RE: **Lot 22 Block 1 Volcano Cliffs Unit 22 SAD 228**
8008 Agua Fria Ct. NW
Grading and Drainage Plan
Engineers Stamp Date: 10/29/2020 (D10D003N22)
CO Certification Date: 6/15/2023

DRAINAGE AND TRANSPORTATION INFORMATION SHEET (REV 11/2018)

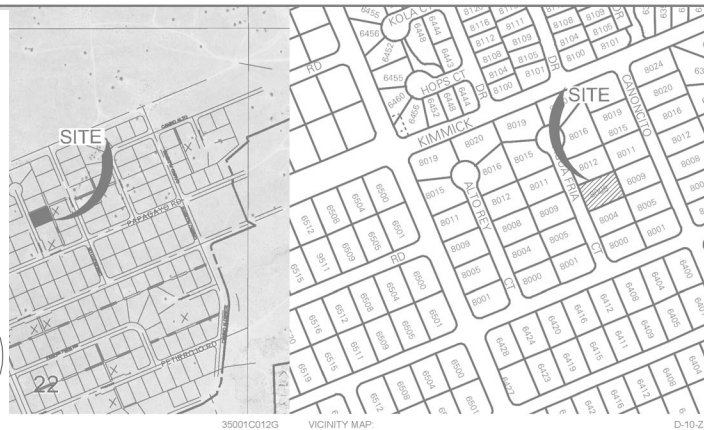
- The channel going from Alto Rey Ct to Agua Fria must be cleaned and free of debris.
